DISTRICT WIDE SCHOOL UPGRADES – HVAC NAUGATUCK, CONNECTICUT 06770

S/P+A PROJECT NO. 16.041

Date Issued: July 25, 2016

The following changes to the Drawings and Project Specifications shall become a part of the Drawings and Project Specifications; superseding previously issued Drawings and Project Specifications to the extent modified by Addendum No. 1.

ROOF FRAMING PLAN

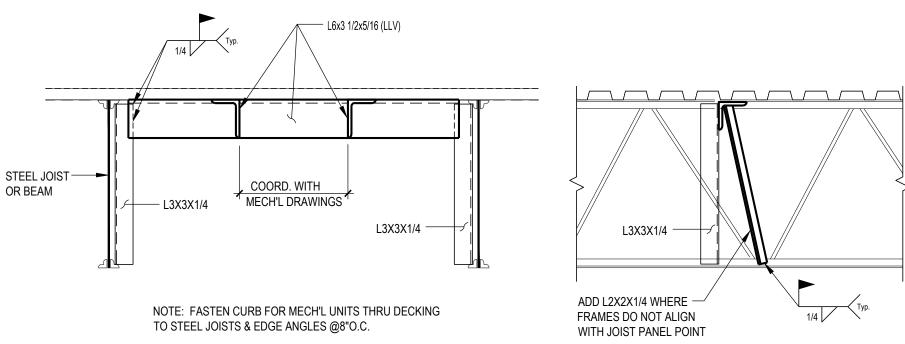
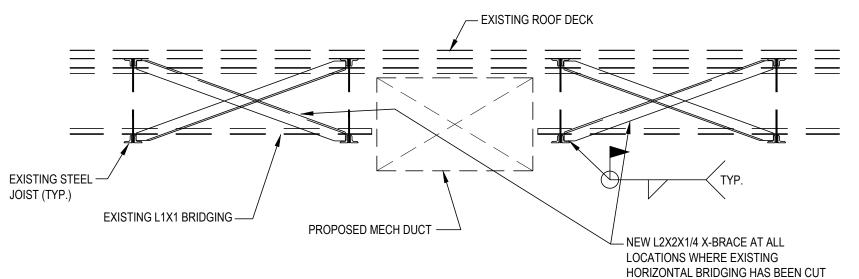
• S100, ROOF FRAMING PLAN, has been added and is attached as part of this addendum.*

ESK
101-01

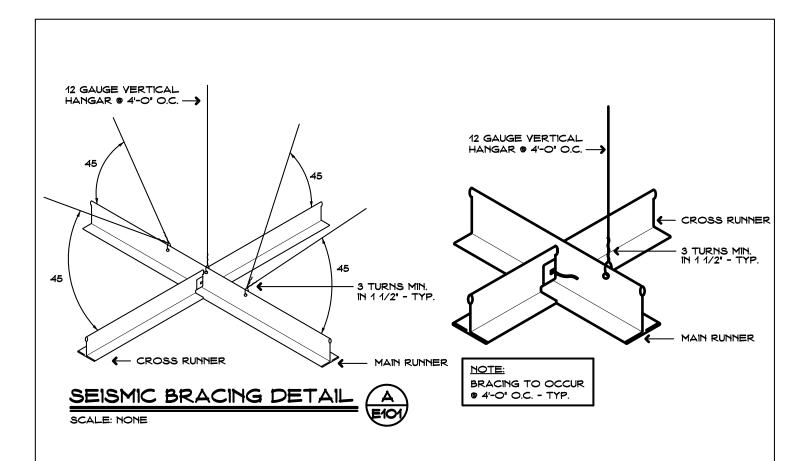
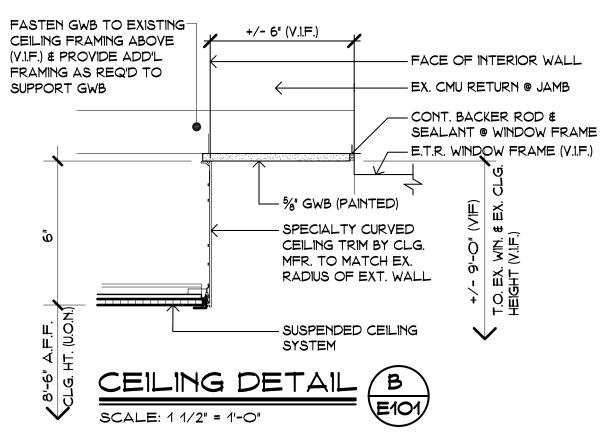
- ESK101-01, ANDREW AVE. HVAC CEILING PLAN & DETAILS, has been added and is attached as part of this addendum. This adds information to Drawing E101.
- ESK101-02, ANDREW AVE. HVAC CEILING PLAN & DETAILS, has been added and is attached as part of this addendum. This adds information to Drawing E101.

- EXISTING ±9'-0' A.F.F. (V.I.F.), IXI ACOUSTICAL CEILING SYSTEM SHALL BE REMOVED AS REQUIRED TO PROVIDE MECHANICAL & ELECTRICAL WORK, AND AS REQUIRED TO PROVIDE NEW SUSPENDED CEILING SYSTEM. REFER TO MECHANICAL & ELECTRICAL DRAWINGS FOR ADDITIONAL ITEMS TO BE REMOVED.
- 2. PROVIDE 2X2' SUSPENDED CEILING SYSTEM AT 8'-6" A.F.F. WITH LAY-IN FIXTURES. RELOCATE EXISTING-TO-REMAIN SURFACE MOUNTED FIXTURES (ON WALLS & CEILINGS) AS REQ'D SUCH THAT THEY ARE LOCATED BELOW THE NEW SUSPENDED CEILING SYSTEM. REFER TO MECHANICAL & ELECTRICAL FOR MORE INFO.
- 3. PROVIDE RADIUSED PERIMETER CEILING TRIM & GWB SOFFIT AT WINDOW OPENINGS REFER TO DETAIL B/EIOI FOR MORE INFO.
